Access Compliance Report

Public Rights-of-Way (Curb Ramps)

Intersection ID: 14547	Main Street: EAST_BV	Cross Street: SPRINGDALE_AV	Location: SW
ADA ID: F8FF2EBB9DE6	Ramp Type: BlendTrans1	Initial Pass/Fail: Pass	Overall Compliance: No
		Severity Score: 0

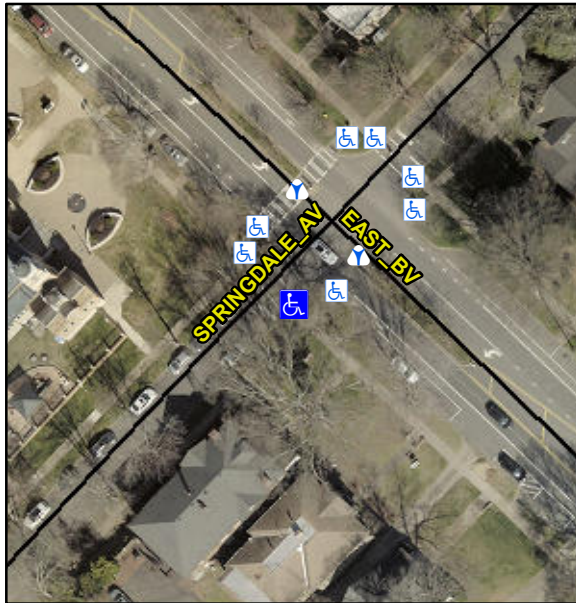
Remove & Replace Detectable Warning System. Remove & Replace Gutter.

R305.2, R304.5.3
